Bayside Planning Panel

Item No	6.1
Application Type	Development Application
Application Number	DA-2017/353
Lodgement Date	15 May 2017
Property	47 Churchill Street, Bardwell Park
Owner	Mr P J Poulos and Ms V Patsos
Applicant	Michael Kitmiridis Architect
Proposal	Alterations and additions to existing dwelling comprised of ground and first floor addition, new front fence and vehicular footway crossing
No. of Submissions	Nil
Cost of Development	\$200,000.00
Report by	Michael Maloof, Senior Development Assessment Planner

Supplementary Planning Report

Application Number: DA-2017/353

Figure 1. Comparison of Western Elevation (Hutchinson Street) of previous plans (top) to amended plans (bottom),

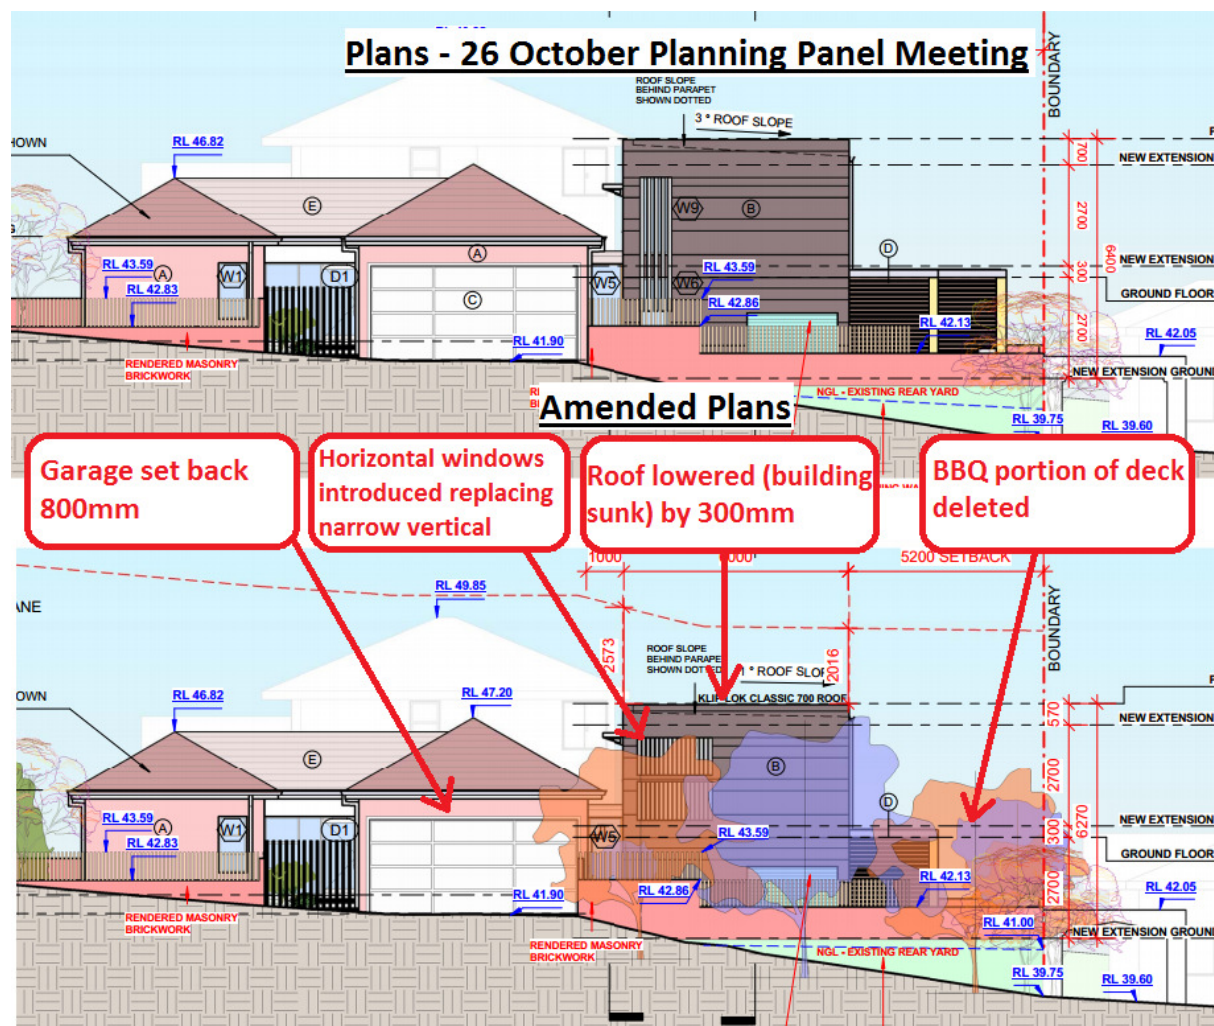
On 1 November 2017, Council received amended plans and these were passed on to the Consulting Assessment Officer on 3 November 2017. The amendments are summarised in the points below and illustrated in **Figure 1** below which compares the previous western elevation with the revised western elevation.

- Rear addition lowered by 300mm;
- Rear addition western (Hutchinson Street) elevation windows changed from 700mm wide vertical windows to 1600mm wide horizontal windows;
- Garage setback to Hutchinson Street increased from nil to 800mm; and,
- BBQ portion of deck deleted and replaced with lawn resulting in the provision of a continuous strip of lawn along the rear boundary.

The amendments are considered to have resulted in an improved streetscape presentation of the development. The rear addition is no longer considered to dominate the original portion of the dwelling as the height has been lowered such that the parapet is nearly aligned with the ridge of the original dwelling. Furthermore, the

narrow vertical windows to the Hutchinson Street elevation have been replaced with larger horizontally proportioned windows which provide softening and fenestration to this elevation. The horizontal proportions are also considered to reduce the perceived height and bulk of the structure and better integrate the addition with the original portion of the dwelling.

5 West Elevation Streetscape
1 : 100

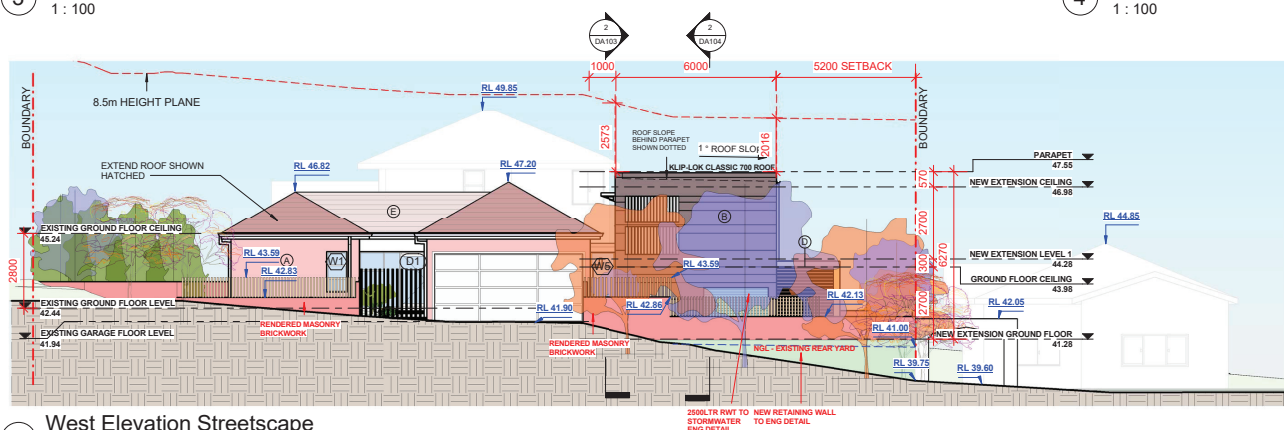
The key amendments made to the proposal were a lowering of the rear addition by 300mm, widening of the window to the Hutchinson Street elevation of the rear addition, setting back the garage 800mm from the Hutchinson Street frontage, and deletion of the BBQ deck area.
